POST BID ADDENDUM NO. 4

Additions and Renovations to Edgewood Intermediate School 7620 E Edgewood Ave. Indianapolis, IN, 46239

ADDENDUM FOUR

Addendum Four (AD.04) to the drawings and specifications prepared by Gibraltar Design and The Skillman Corporation for **Edgewood Intermediate School Additions and Renovations** for Franklin Township Community School Corporation, Indianapolis, Indiana.

A-111

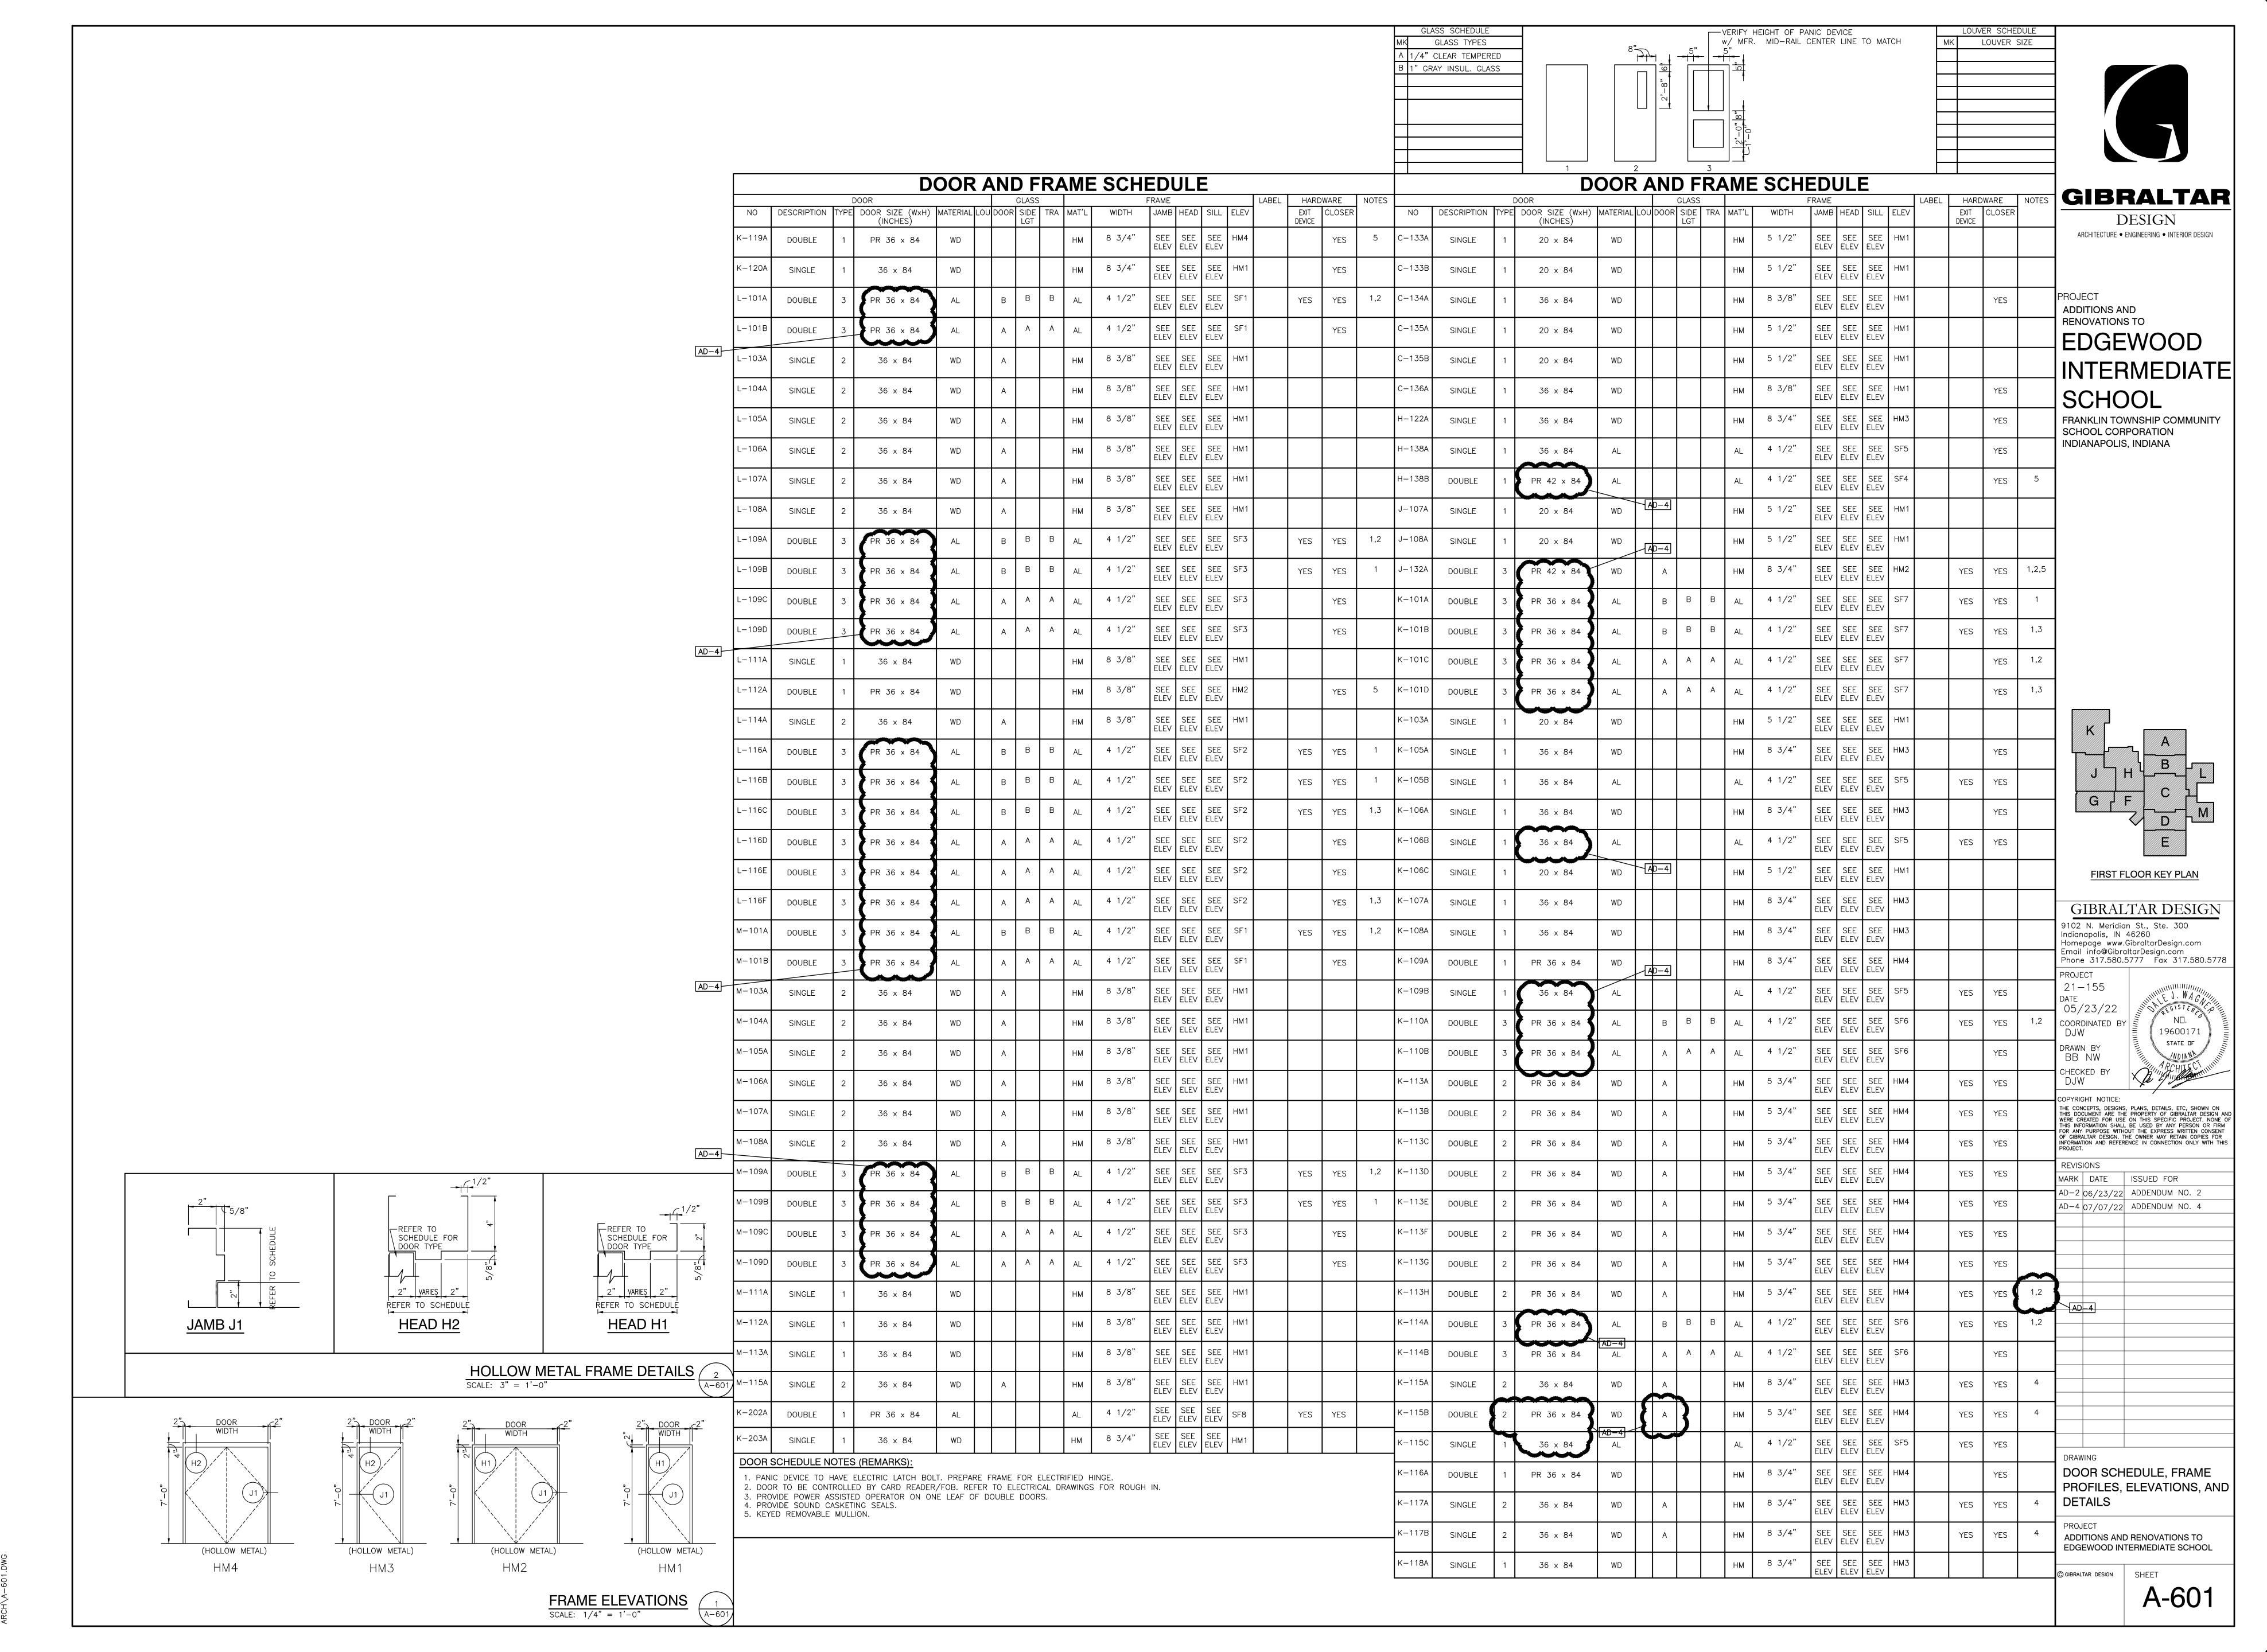
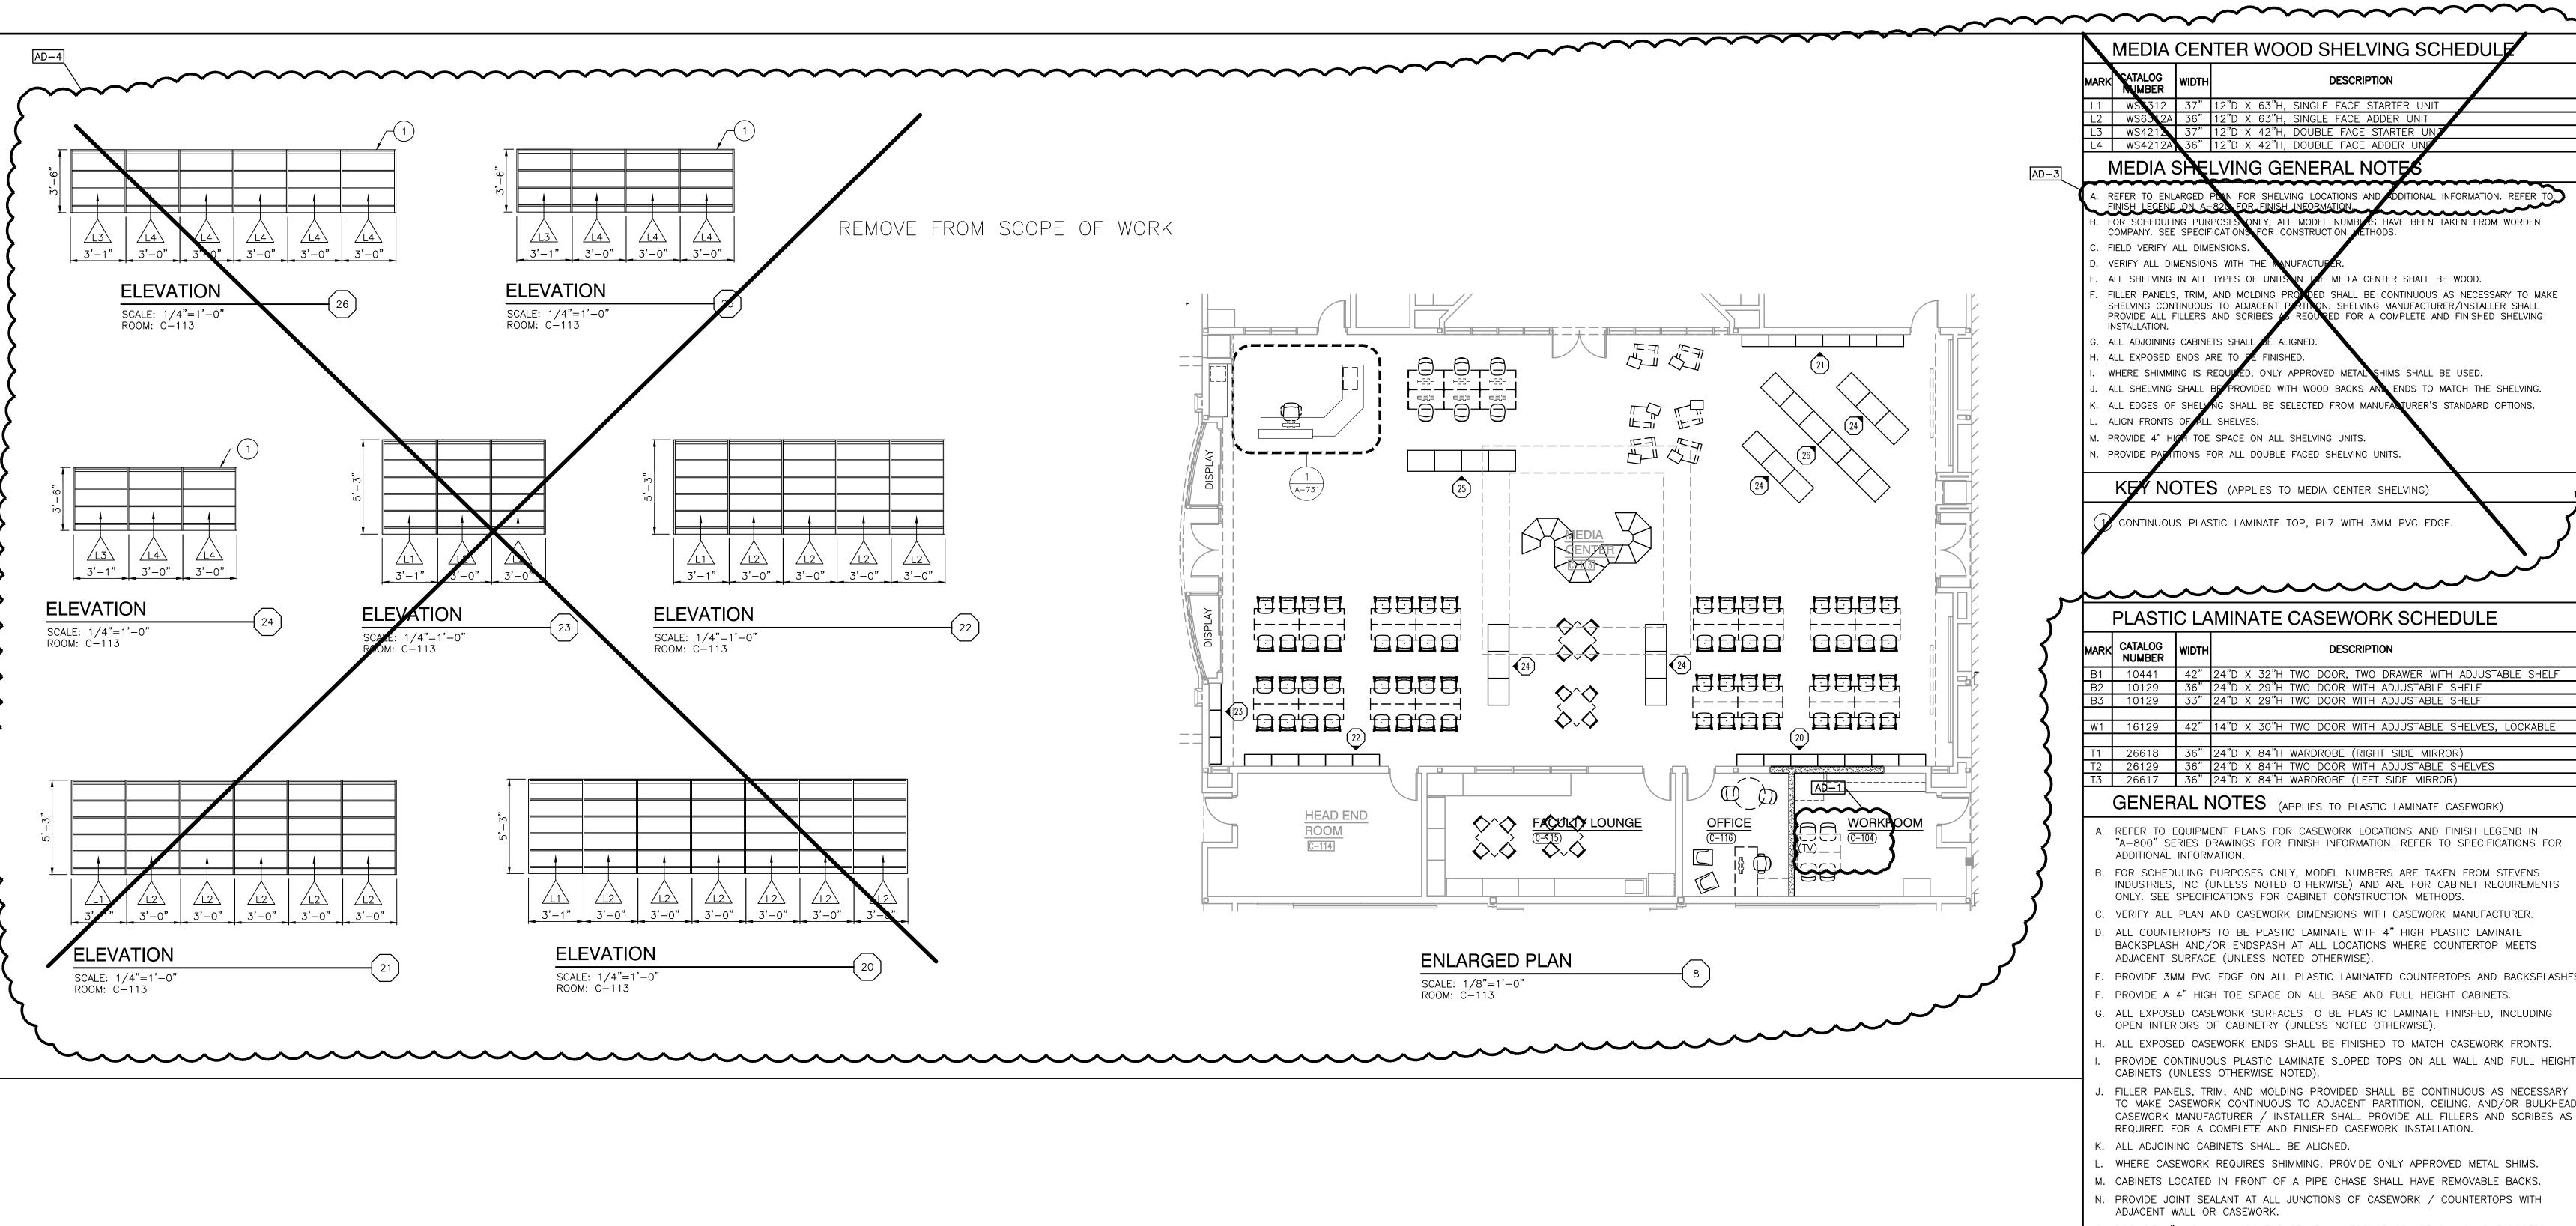
- 1. Sheets A-111
 - A. Refer to revised full size drawing, included in this Addendum, for locker type in Boys Locker K-105 and Girls Locker K-106 see Sheet A-420.
- 2. Sheet A-730
 - A. Refer to revised full size drawing, included in this Addendum for revisions.
- 3. Sheet A-601
 - A. Refer to revised full size drawing, included in this Addendum for revisions.
